Service Letter No. 444

SUBJECT: Installation of Special Steel Fittings on Auxiliary Fuel Pumps

MODELS AFFECTED: PA-24 "250" Comanches only, Serial Nos. 24-103 to 24-2299 inclusive

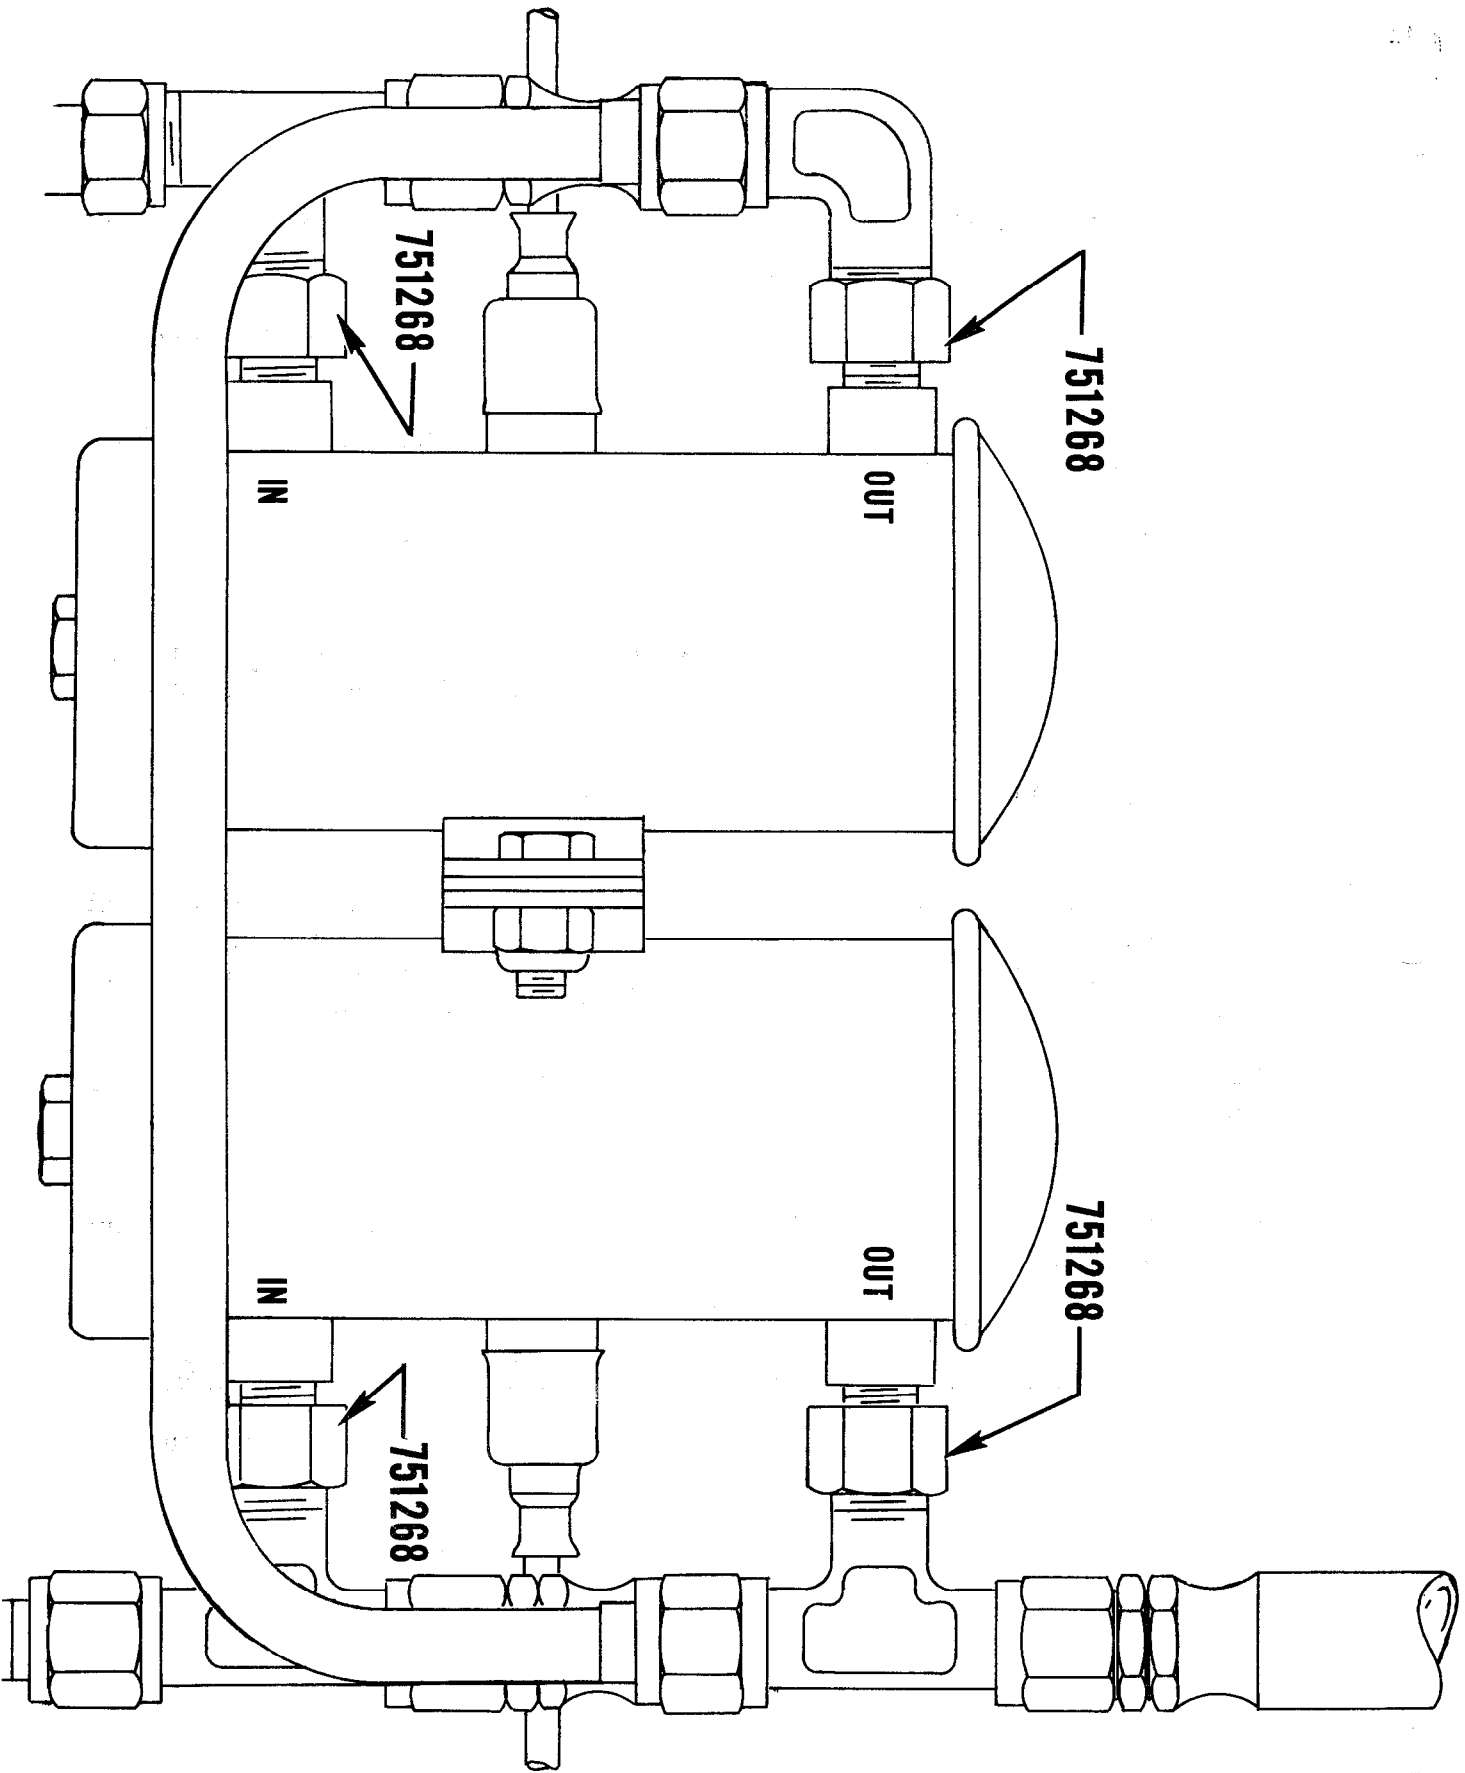
The dual electric fuel pumps installed in the PA-24 "250" Comanches as original equipment have a brass Weatherhead reducer fitting at each end of the fuel line attaching points at the pumps. These brass reducer fittings have developed cracks from over-tightening during maintenance operations, resulting in fuel leaks.

Special steel fittings are now available to replace the present fittings, eliminating the brass Weatherhead bushing. Reference to the accompanying sketch shows the location of the new steel bushings installed.

Each aircraft will require a total of four (4) fittings and they may be ordered from the Service Spares Department as follows:
